P5007A-02

Information Only Service Note

P5007A Keysight Streamline USB Vector Network Analyzer

False alarm on self-test failure on firmware revision of A.13.40.02 - DDR3 memory removal

Self-test

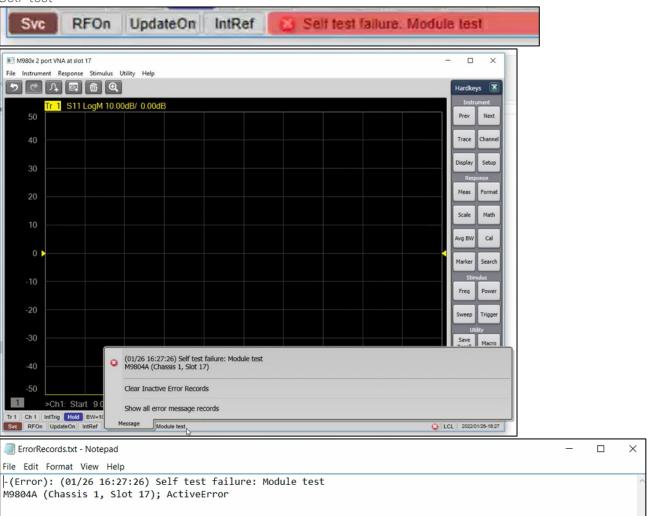
The on board DDR 3 memory in VNA is not in use since its release. With the removal of DDR 3 memory IC on newer P500xA VNA, right after firmware is launched, false alarm (self-test failure) will be reported as shown. This has no impact to VNA performance and specifications.

Similarly, firmware will report a false failure in Operator check. Shown are the error messages example on VNA firmware UI.

Since this DDR3 memory is not in use, newer firmware revision no longer consider it as the failure. Keysight recommends keeping VNA firmware up-to-date whenever it is possible.

For users with firmware revision of A.13.40.02, Update firmware to revision A.13.70.02 or newer to resolve this false alarm on self-test.
